STAFF RECOMMENDATION 1208 Paris Avenue November 19, 2018

Application: New Construction – Addition and Outbuilding
District: Belmont-Hillsboro Neighborhood Conservation Zoning Overlay
Council District: 18
Map and Parcel Number: 11801006200
Applicant: Duane Cuthbertson
Project Lead: Sean Alexander, sean.alexander@nashville.gov

Description of Project: The applicant proposes to enlarge an historic one and one-half story house with an addition that will be taller and wider, and to construct an outbuilding for use as a detached accessory dwelling unit.

1208 PARIS AVENUE SITE PLAN

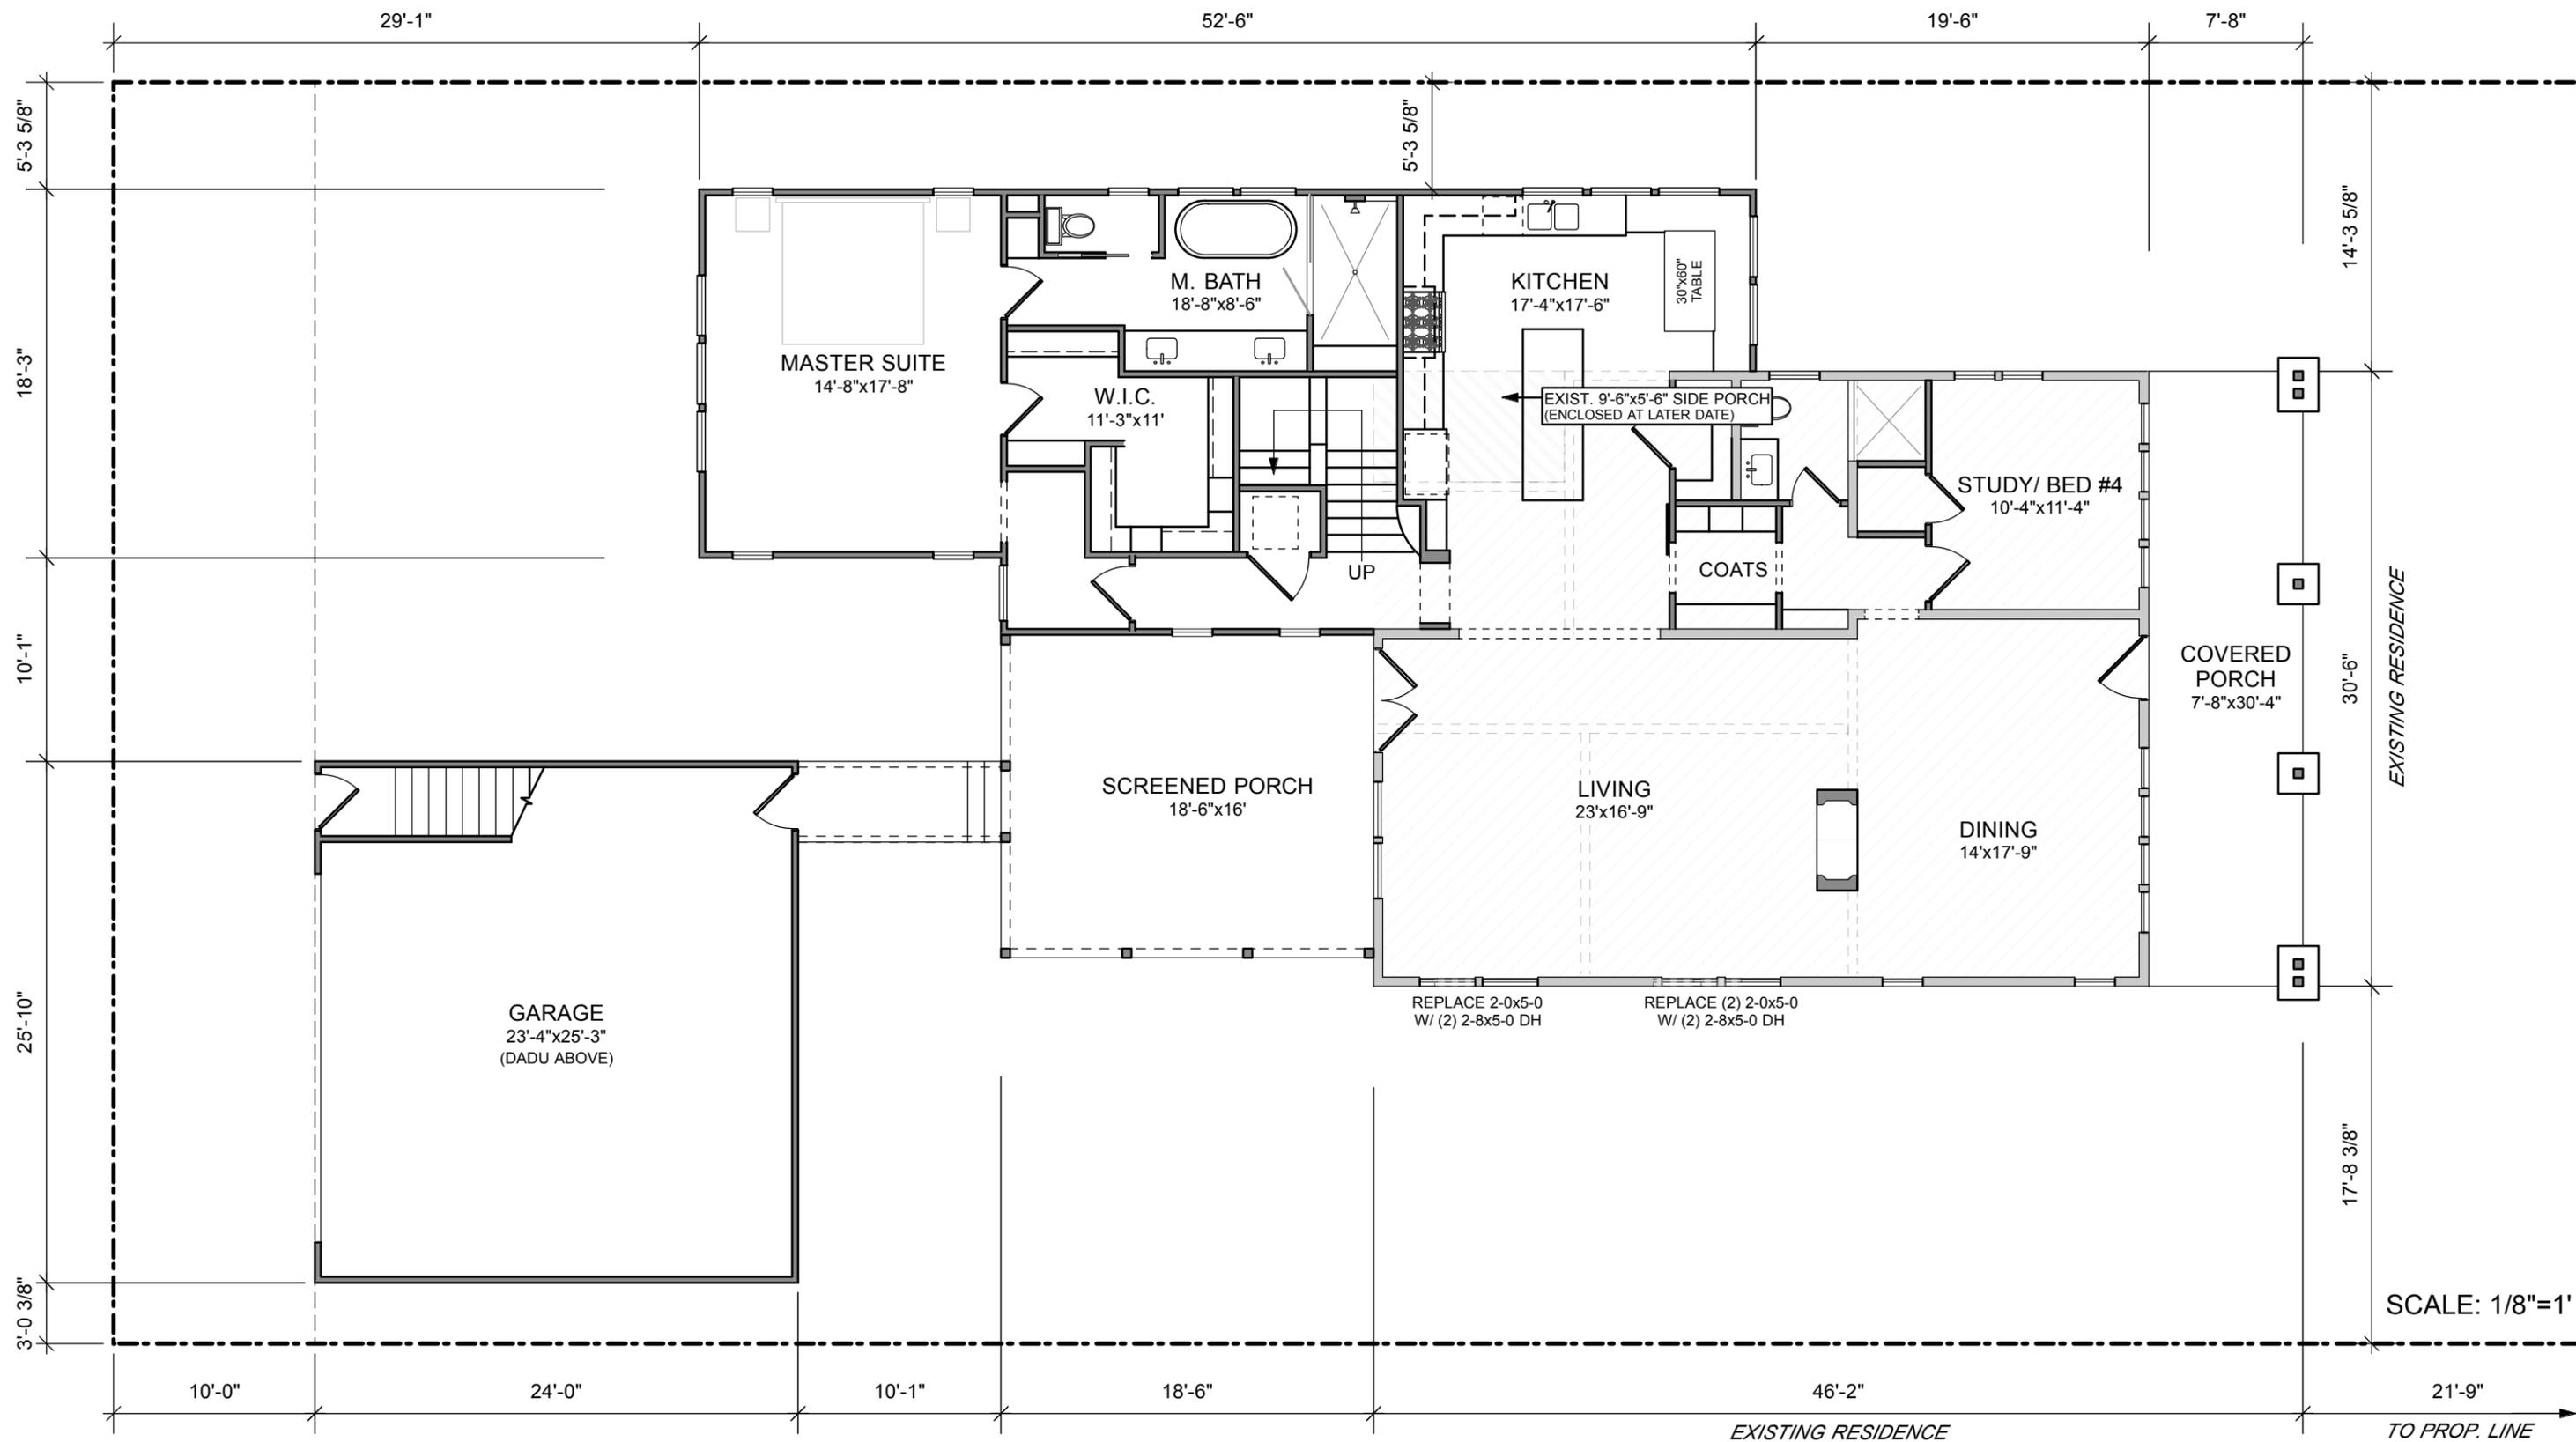
Analysis and Findings: The applicant proposes to enlarge the house with a side and rear addition that will wrap the rear-right corner of the house and be taller, and to construct an outbuilding for use as a detached accessory dwelling unit.

Setback & Rhythm of Spacing: The historic context in this section of the Belmont-Hillsboro neighborhood is composed of mostly one story houses and one-half story houses with side yards and driveways between most buildings. Staff finds that the addition expanding the width by nine feet (9') to the right on the first story will meet the

Staff finds that a side addition and rear addition are appropriate and would meet section II.B.2.e of the design guidelines with a condition that they are separated and not wrap the corner of the historic house.

1208 PARIS AVENUE

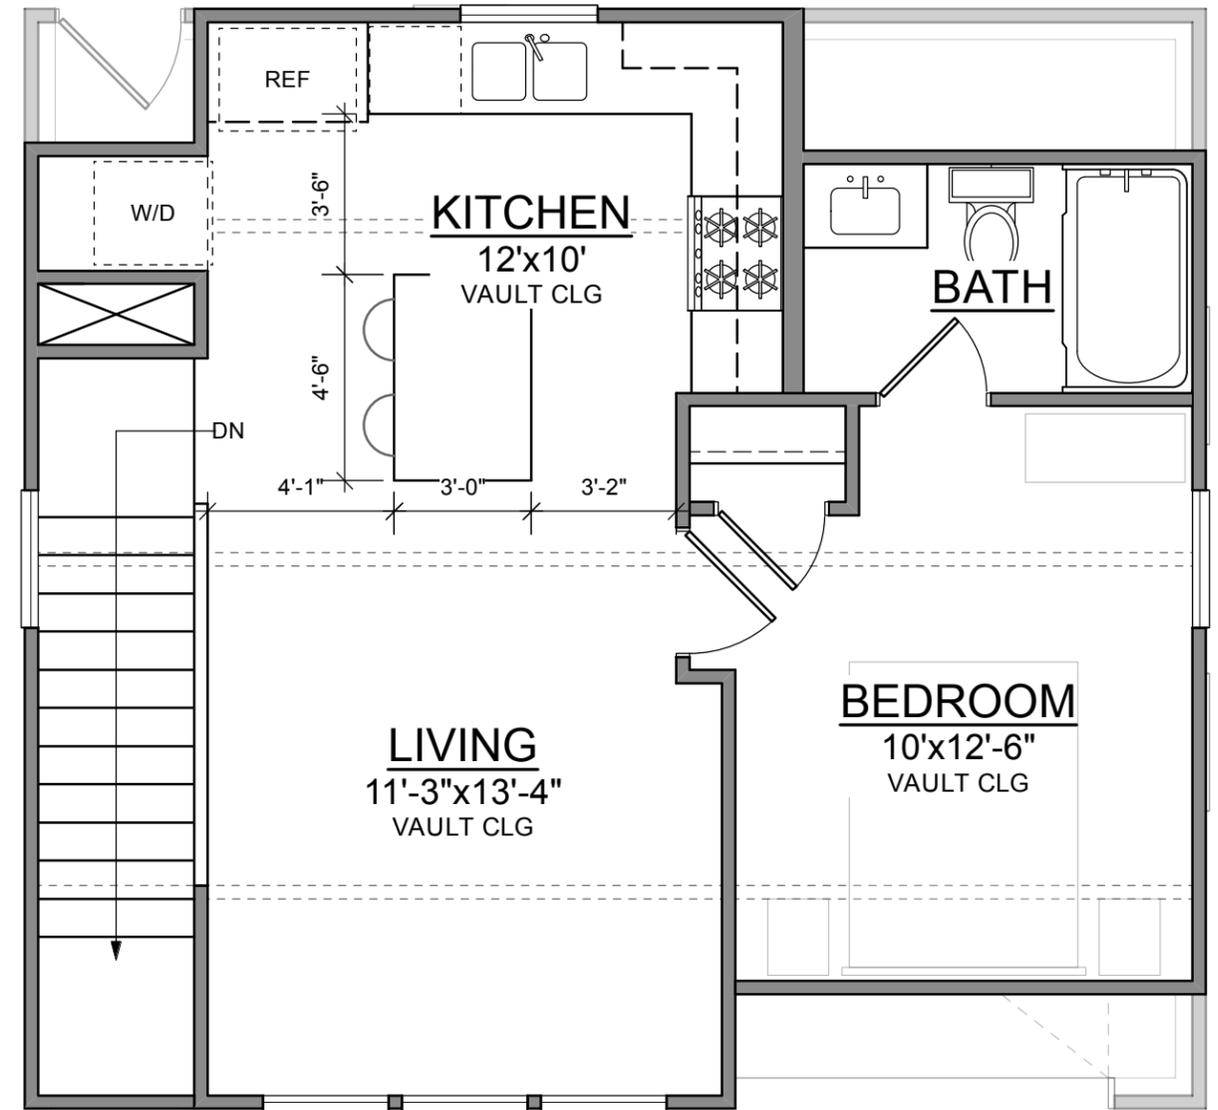
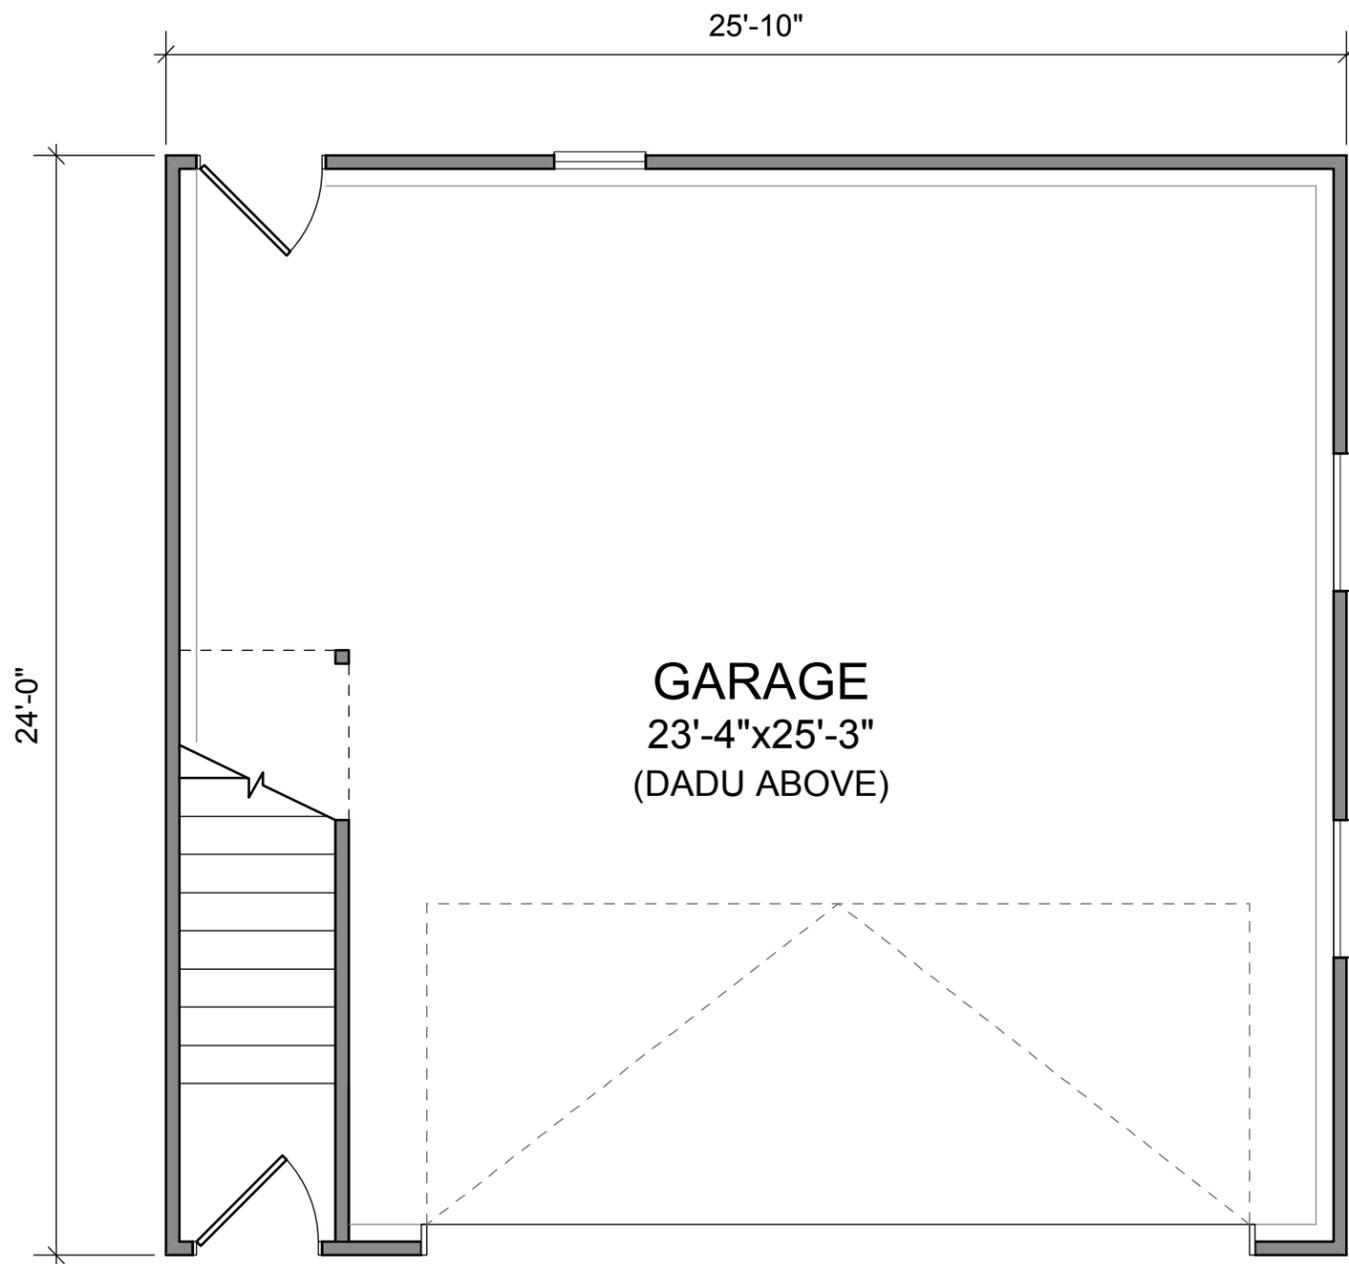
Location & Removability: The proposal includes a one and one-half story addition to the one and one-half story house. On the left side the addition is stepped in eighteen inches, and although the addition is one and one-half story the impact is lessened because the lower level is an open porch on the left side. The project includes a side addition on the right that originates behind the midpoint of the house and extends fifty feet (50') toward the rear. The rear and right side additions are connected, wrapping the rear-right corner of the house's walls and eaves.

Height & Scale: The addition to the right side will originate behind the midpoint of the house on the right side and extend nine feet (9') to the right. On lots wider than sixty feet (60') side additions may be appropriate. The roof of the side addition will hip up to the left and cover the lower five feet (5') of the right side gable and eave. From there the addition continues up behind the house toward the center, reaching a peak height at three feet, eleven inches (3'-11") higher than the ridge of the historic house.

The italicized portion of the design guidelines for additions say that "*Whenever possible, additions should not be taller than the historic building; however, when a taller addition is the only option, additions to single story structures may rise as high as 4' above the shadow line of the existing building at a distance of 40' from the front edge of the existing building. In this instance, the side walls and roof of the addition must set in as is typical for all additions.*" Staff does not find that the applicant has demonstrated that four feet (4') of additional height is the only option for this addition. For example, the applicant has not considered a ridge-raise addition which would increase the height by up to two feet (2'), or another roof form that might provide comparable interior upperstory space at a lower height. Additionally, the proposed addition would not only be four feet (4') taller than the historic house, it would be nine feet (9') wider and does not set in from the right side wall as is typical for all additions.

With a condition that the height of the upperstory is reduced to no higher than two feet (2') above the ridge of the historic house and the right side does not wrap the corner, Staff finds that project would meet sections II.B.1.a and II.B.1.b of the design guidelines
